**RESPONSE TO OBR PROJECT ISSUES CHECKLIST  
LATEST DATE OF JULY 3, 2019,  
PROJECT NUMBER # PDS2016-TM-5615,  
PDS2016-MUP-16-012, PDS2016-MUP-16-013  
BY COUNTY OF SAN DIEGO**

**W.O. 6960-A7-SC     JULY 29, 2019**

Subject: Response to OBR Project Issues Checklist, Latest Date of July 3, 2019, Project Number# PDS2016-TM-5615, PDS2016-MUP-16-012, PDS2016 - MUP-16-013, by County of San Diego.

PA-3  
Re-Revised Plate 1

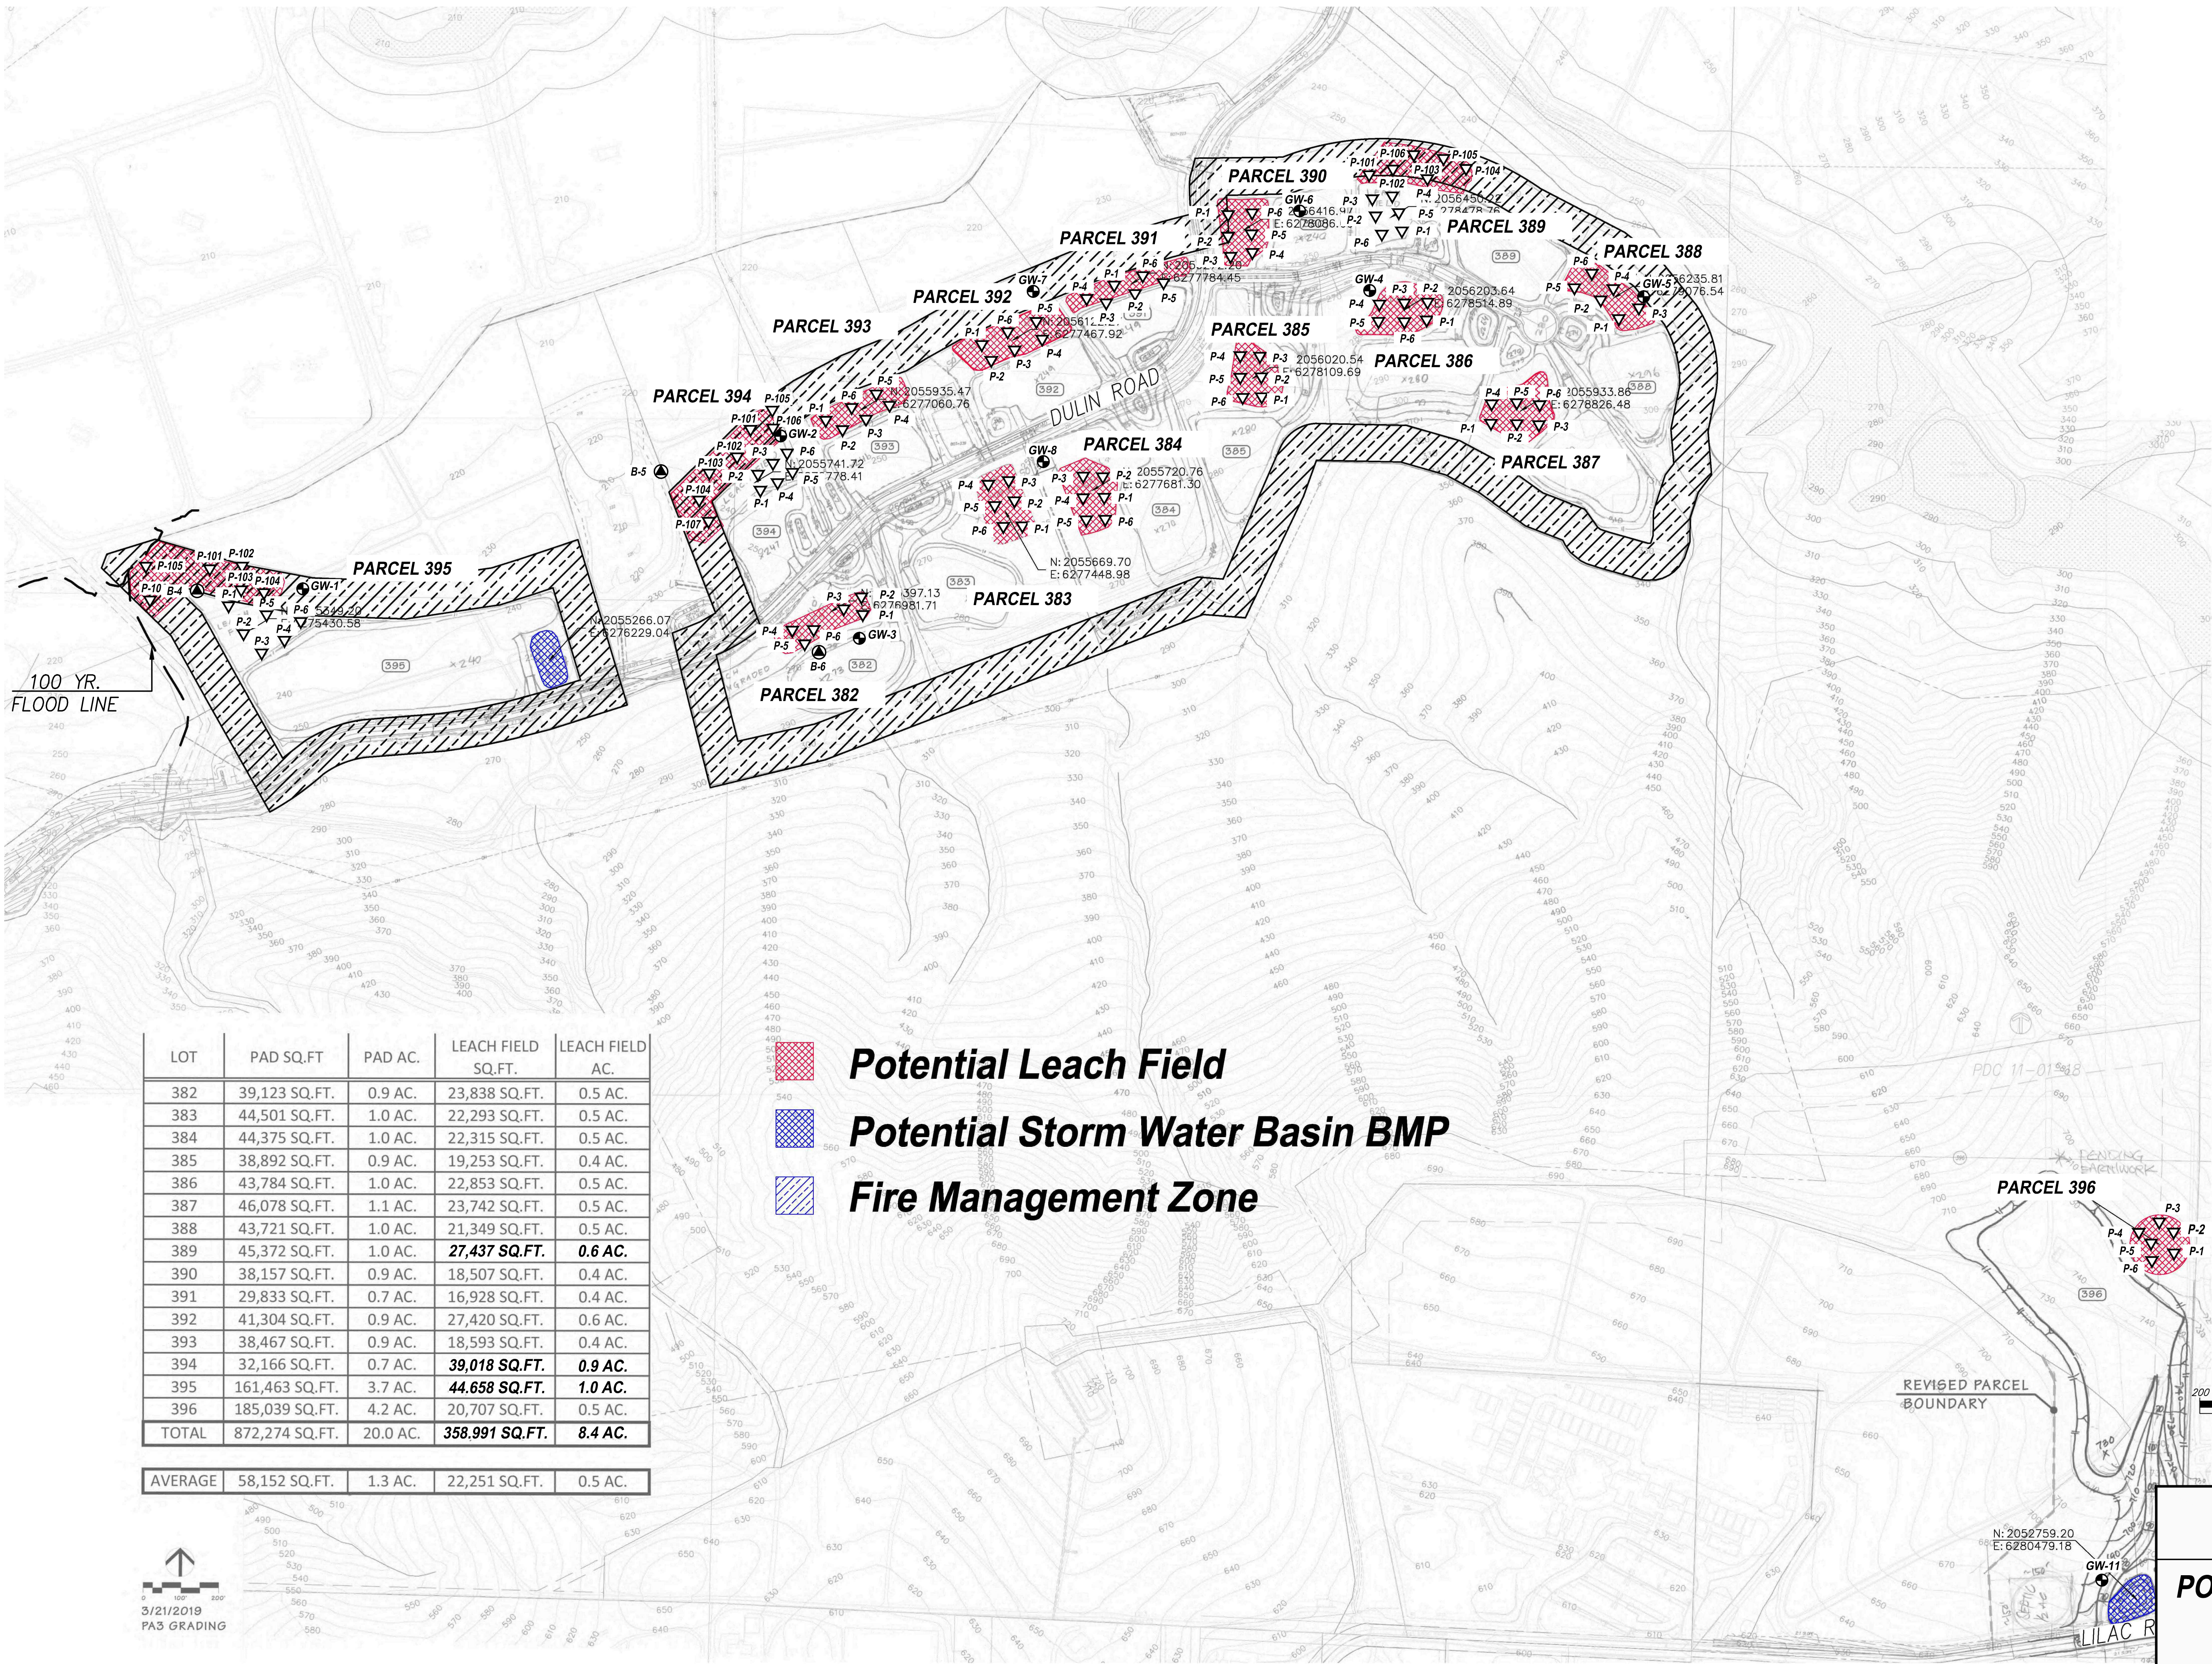
*The groundwater borings (GW1-GW11) completed as part of the percolation testing were drilled between 4/16/19 and 4/19/19. All these excavations were backfilled on the day that they were drilled, according to the boring logs provided. The excavations at GW3 and GW9 indicate that water seepage zones were encountered at 7'-8'. None of the excavations had piezometers installed for the purposes of groundwater monitoring. The Percolation Feasibility Study indicates that groundwater levels during March 2014 were encountered at 13.5' to 15.5' below existing grade along the northern edge of PA-3. Groundwater measurements at those levels, following a three-year period of below normal precipitation, are concerning. The rainfall totals (July1-June 30) for the Fallbrook station were shown to be 10.27" for 2011-2012, 8.35" for 2012-2013, and 6.99" for 2013-2014. All well below the 14.13" average reading. DEH requests that piezometers be installed to a depth of at least 20' at the lowest proposed elevations for the primary/reserve leach field areas at B9, R7, R8 and parcels 382, 394 and 395. The applicant should notify DEH once these have been installed so that measurements can be taken.*

Six (6) borings (see the Appendix) were advanced within Planning Area 3 of the site, in the vicinity of the proposed R7, R8, and B9 leach fields, as well as parcels 382, 394 and 395, and were extended to depths of ranging from about 14½ feet (refusal) to 22 feet below existing grade for the installation of piezometers, and DEH was notified. The groundwater data is summarized in the following table, and the locations of the borings are shown on re-revised Plates 1 and 2.

Re-Revised Plate 2

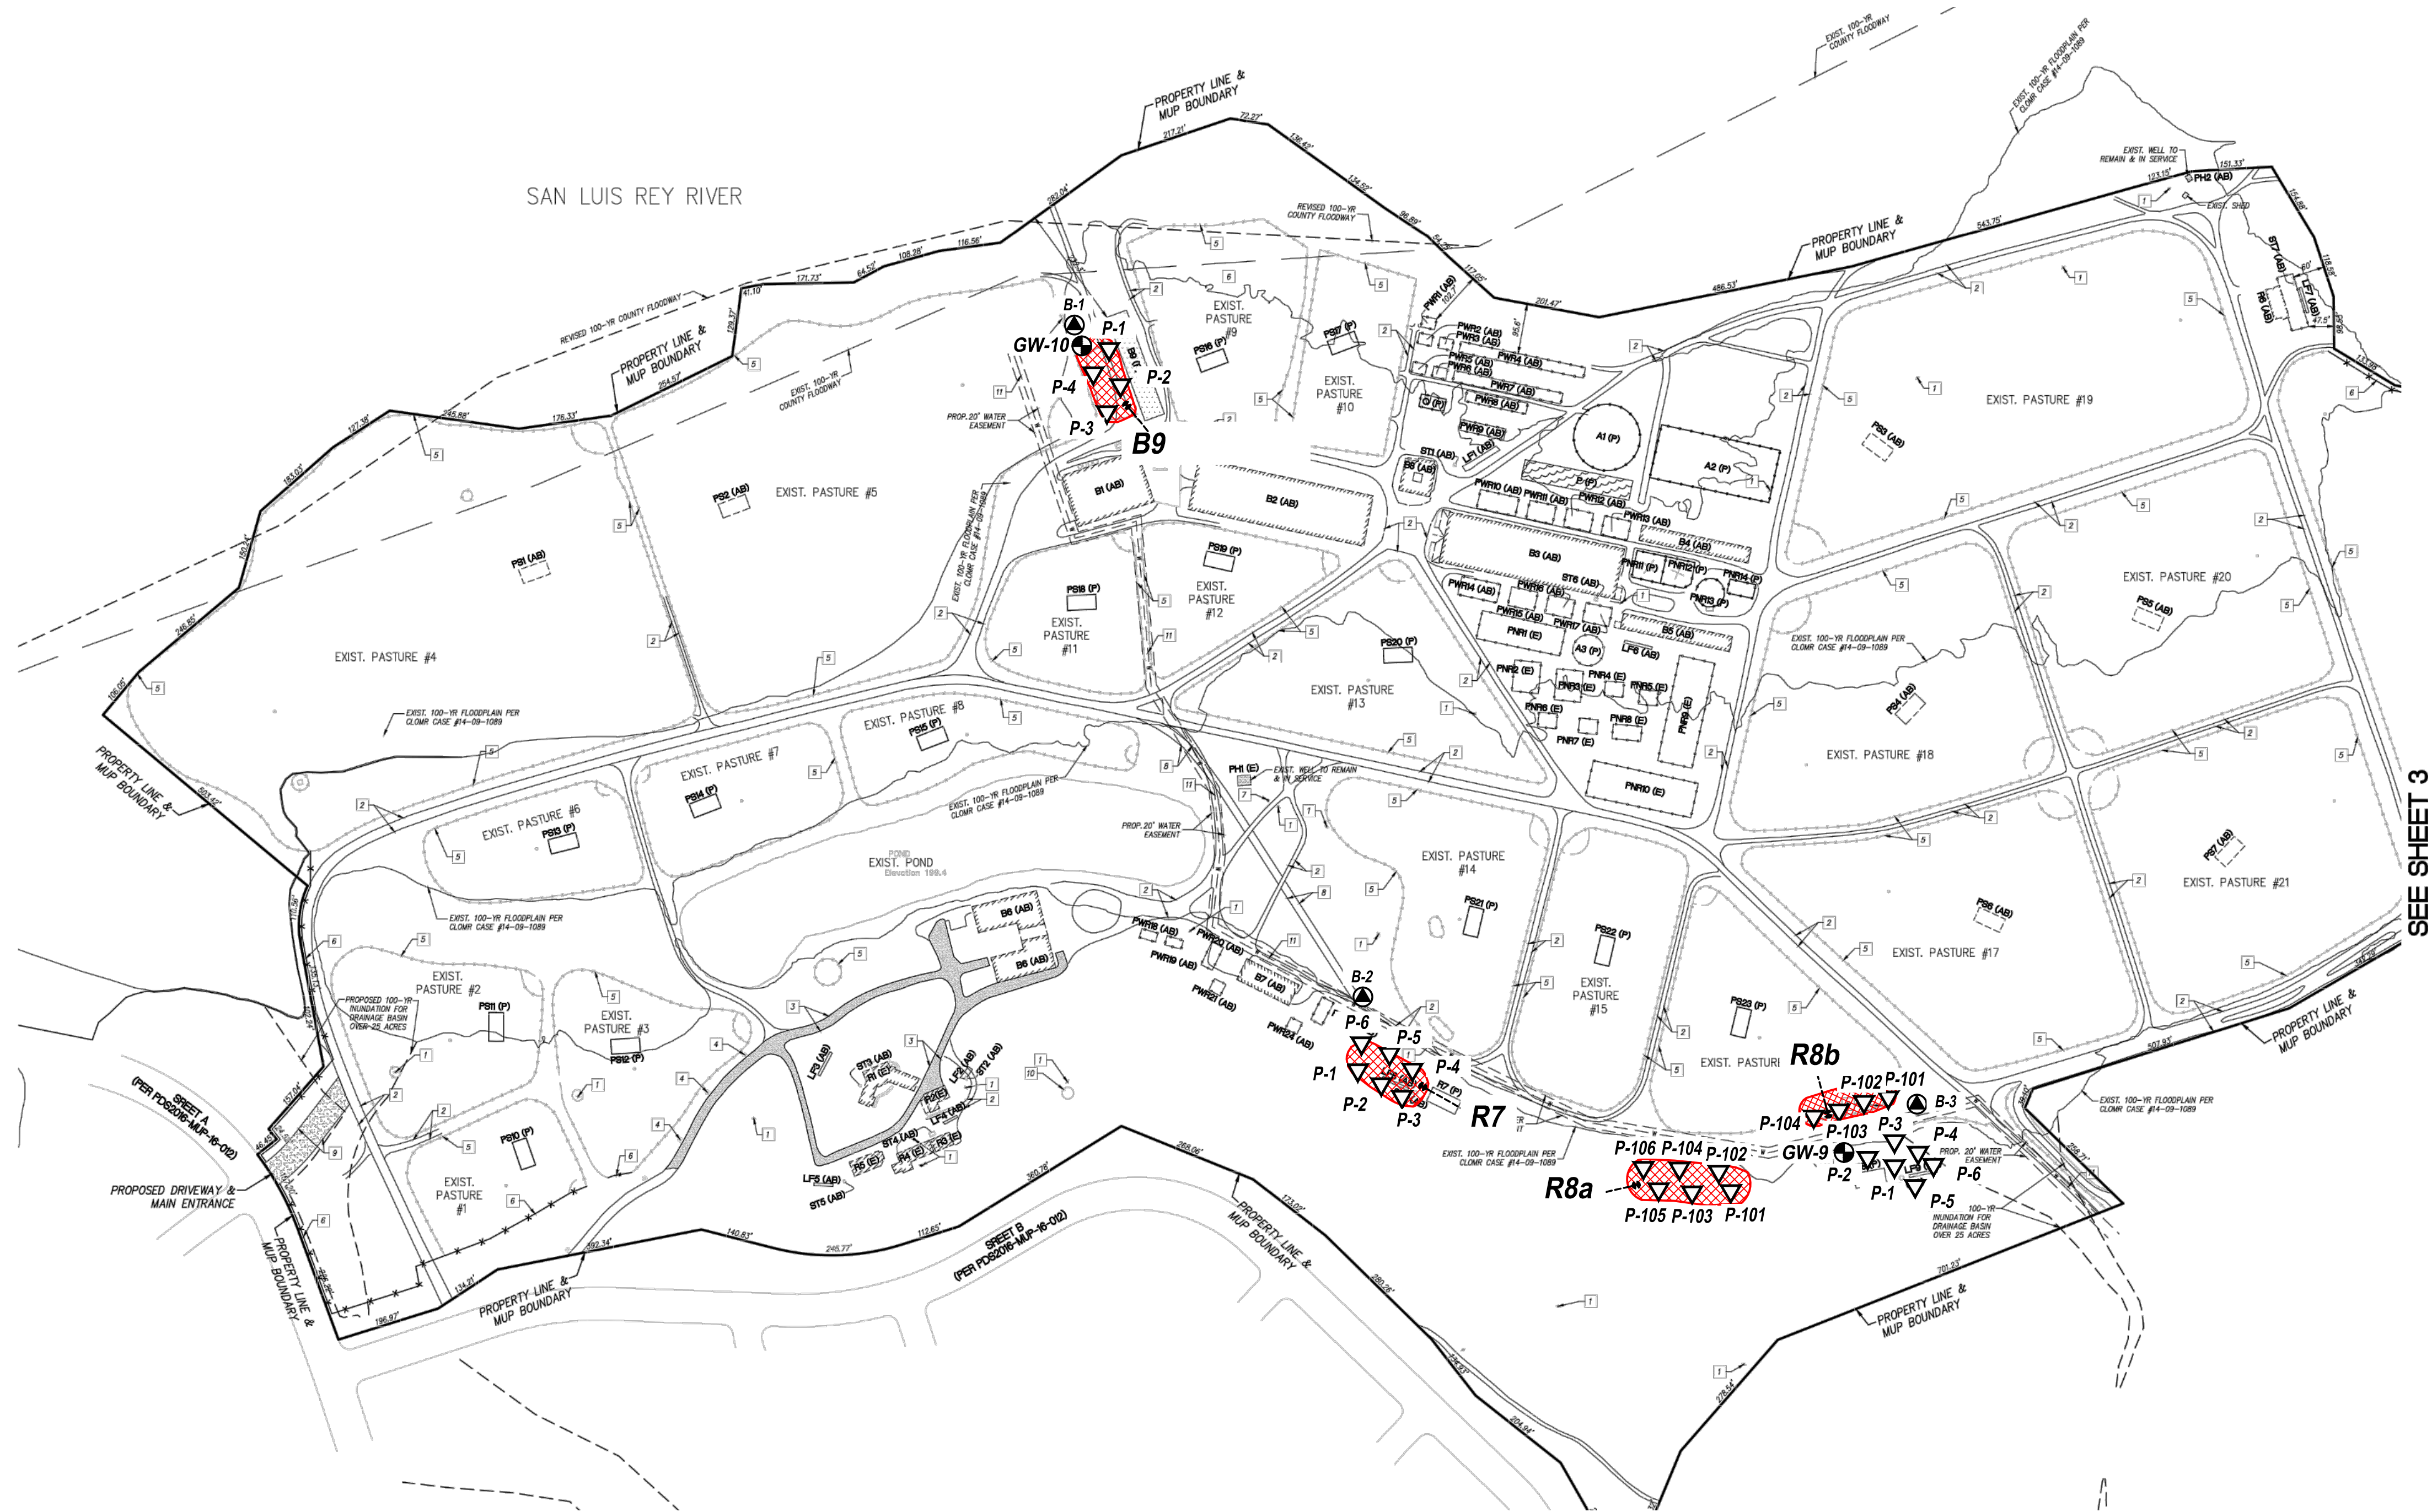
*The proposed leach field area shown for R8b is directly adjacent to the water line easement. Revise the leach field location to allow for the 25' setback from the water line or 10' from the easement, whichever is greater.*

Acknowledged. The revised location of the leach field is shown on re-revised Plate 2.
